CITY COUNCIL MEMORANDUM

SUBJECT: ZC23-0050, Ordinance No. 3778, Public hearing and consideration

of a request from Rick Figueroa for a special development plan for a transitional parking lot at 6412 Davis Boulevard, being 6.93 acres described as Tracts 2A2, 2A2F, 2C1, 2C1D, and 2C1D1, John H. Barlough Survey, Abstract 130. (CONTINUED FROM THE

PROPOSED TRANSITIONAL PARKING LOT

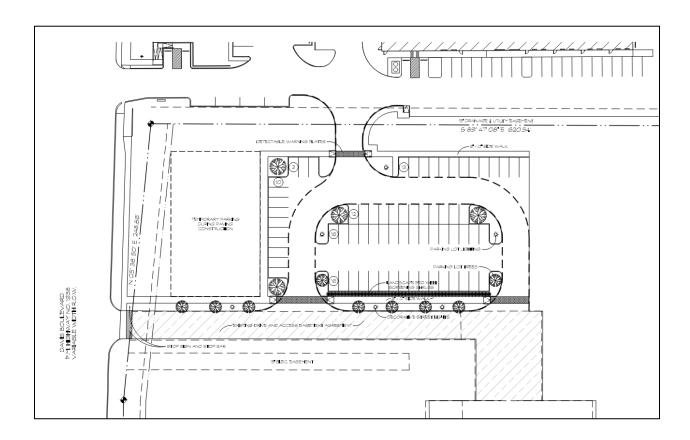
The proposed improvements include the construction of a new concrete parking lot with 70 spaces on the north side of the existing gas valve site access drive. A parking lot drive

aisle would connect to the property to the north, spanning an existing earthen drainage channel between the two properties. The connection would accommodate both vehicles and pedestrians. The drainage channel is located on property not owned by the applicant, and an easement must be obtained in order to make the connection.

As part of the request, the applicant is seeking approval to allow parking on grass until the construction of the new parking lot is complete. The applicant has identified an area of about 9,000 square feet at the northwest corner of the property along Davis Boulevard that would be used for temporary grass parking for customers of the gym and the new building to the north. The Development Review Committee recommends denial of this part of the request, and that the applicant comply with Section 118-831(9) of the Zoning Ordinance, which requires parking on paved surfaces.

While this accommodates existing off-site uses, the Development Review Committee is concerned about the future use of the subject property. The applicant has demonstrated plans for a 7,200 square foot retail/restaurant building (29 required parking spaces) and other uses. A conceptual layout provided by the applicant shows future development to follow the standard parking requirements of the TOD Code.

DRC REVIEW: The Development Review Committee (DRC) evaluated the proposal based on the design intent and standards for the Smithfield TOD area and recommends denial of the request as presented. The DRC recommends that the applicant apply for an amendment to the most recent SDP for the property to the north to incorporate the subject property to accommodate all current and proposed uses and parking.

- 1. Temporary grass parking on the property is prohibited except for equipment and activities related to parking lot construction.
- 2. The parking lot must support a minimum total of 149 parking spaces between both properties.

- 3. The parking lot must be designed and constructed in accordance with City codes including landscaping and irrigation pursuant to Section 114-71(i) of the City Code regarding landscaping of parking lots. Parking lot lighting must also be installed. These improvements may be deferred six (6) months after the final inspection of the parking lot paving permit.

- 4. The parking lot paving improvements must be completed within nine (9) months of the effective date of City Council's approval of the Special Development Plan.

- 5. A vehicular and pedestrian connection must be made to the property to the north. An access easement to cross the drainage channel must be executed and recorded in Tarrant County property records prior to paving permits. Engineering

design of the proposed vehicular cross-connection showing culvert/drainage design and vertical alignment of the access drive must be approved by the City Engineer prior to issuance of paving permits.

6. The drive aisle and parking lot must integrate features of a TOD General Street, including six-foot wide sidewalks, parking lot setbacks and street trees, and the drive aisle improvements must connect to Davis Boulevard. A minimum five-foot wide sidewalk must be provided along Davis Boulevard between the drive aisle and the north property line.
